Access Compliance Report

Public Rights-of-Way

Intersection ID: 11741	Main Street: COUNTRY CLUB DR	Cross Street: MATHESON AV	Location: N
ADA ID: 7AB69AC20EAE	Ramp Type: MedianPerp	Initial Pass/Fail: Fail	Overall Compliance: No
			Severity Score: 26.25

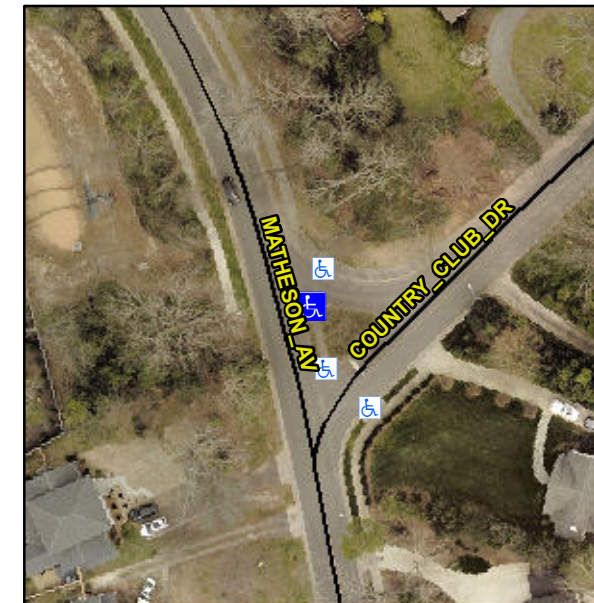
Not Found, R304.2.2, R304.5.3

Compliance	Description	Data	Compliance	Description	Data
N/A	Ramp Length (in)	59.0	No	Ramp Slope (%)	16.4
Yes	Ramp Width (in)	49.0	No	Ramp XSlope (%)	2.5
N/A	Flare Type LT	N/A	N/A	Flare Type RT	N/A
N/A	Flare Slope LT (%)	N/A	N/A	Flare Slope RT (%)	N/A
N/A	Flare Traversable LT?	N/A	N/A	Flare Traversable RT?	N/A
N/A	Landing Length (in)	N/A	N/A	DWS Provided?	N/A
N/A	Landing Width (in)	N/A	N/A	DWS Contrast?	N/A
N/A	Landing Slope (%)	N/A	N/A	DWS Length (in)	N/A
N/A	Landing X Slope (%)	N/A	N/A	DWS Full Width?	N/A
N/A	Landing Curb? (Y/N)	N/A	N/A	DWS Offset (in)	N/A
N/A	Shared Landing?	N/A			
N/A	Gutter Ponding?	N/A	N/A	Gutter Slope (%)	N/A
N/A	Gutter Lip Ht (in)	0.5	N/A	Gutter X Slope (%)	N/A
N/A	Painted X Walk1?	No	N/A	Painted X Walk2?	N/A
	X Walk 1 Direction	To N		X Walk 2 Direction	N/A
N/A	X Walk 1 Width (in)	N/A	N/A	X Walk 2 Width (in)	N/A
	X Walk 1 Slope (%)	2.9		X Walk 2 Slope (%)	N/A
	X Walk 1 X Slope (%)	6.0		X Walk 2 X Slope (%)	N/A

Remove & Replace Entire Ramp.
